NUMBER: 17-004-14

GROUP: Rear Suspension

Right Rear Spring Shifted In Upper Isolator And Possible Clunk Noise

2013 - 2014 (PF)

Fig. 2 Spring Shifted In Upper Isolator

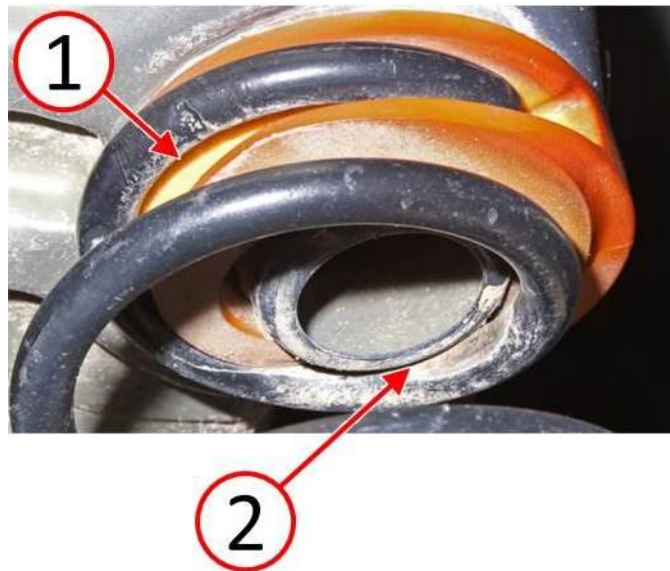
2. Is the right side rear spring shifted in the upper spring seat isolator (1) and/or possibly touching the upper spring seat (2) as shown in (Fig. 2)?
- Yes>>> Proceed to [Step #3](#).
 - No>>> Continue further diagnosis, this bulletin does not apply.

- 3. Replace both the left and right rear springs. Refer to the detailed procedures available in DealerCONNECT> TechCONNECT under: Service Info> 17 - Rear Suspension> SPRING(S)> Removal/Installation.
